A REPAIR

SEWAGE DISPOSAL SYSTEM

HOWARD COUNTY
BUREAU OF ENVIRONMENTAL HEALTH

SUBDIVISION Shephard Glen ROAD 3814 Walt Ann Drive LOT _____

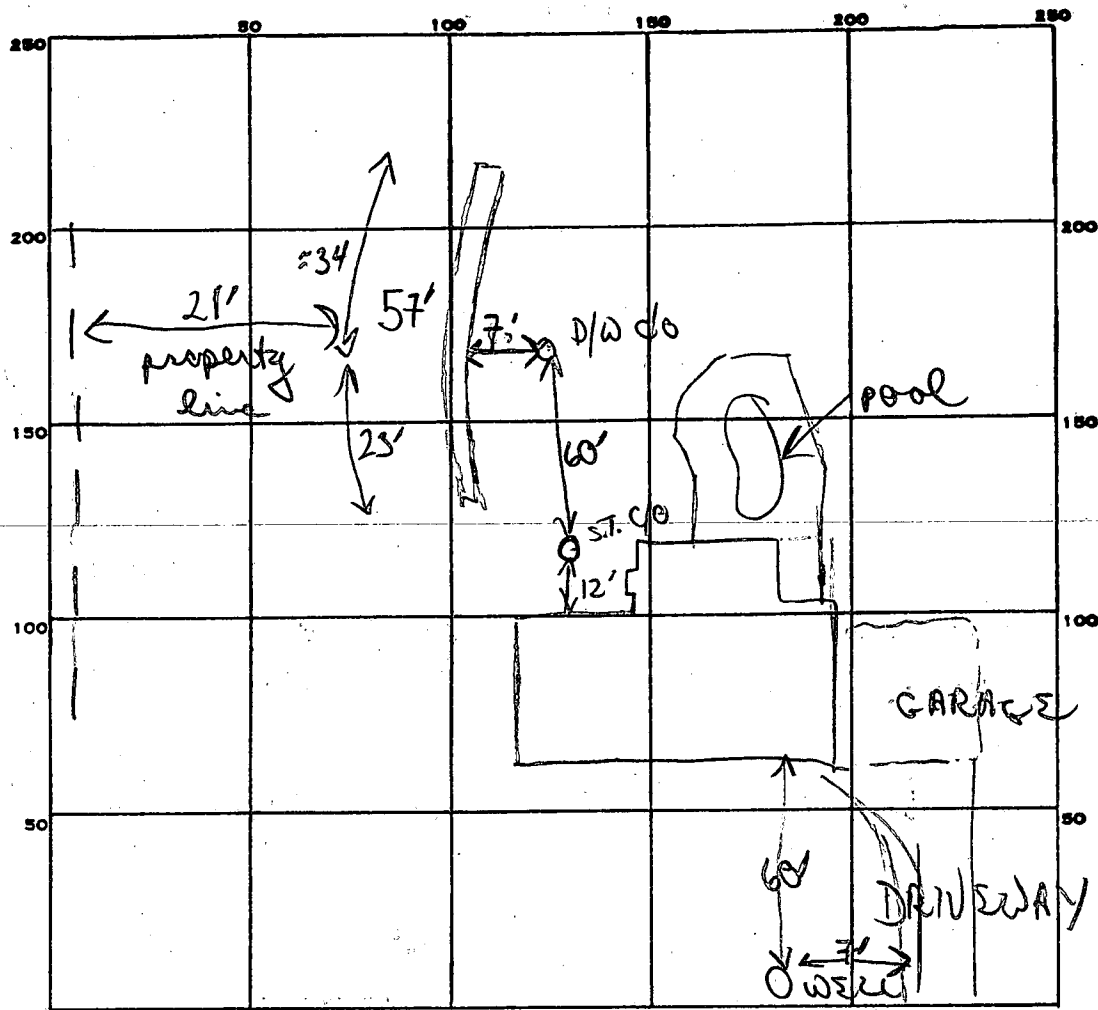
REMARKS 10/8/86 Soils orange tan silty mica (some rock
frag (3-6') OK to go 4' to 11' ft (7' stone) OK to
finish adding stone pipe paper to trench. OK
to top into dry well. OK to cover all work
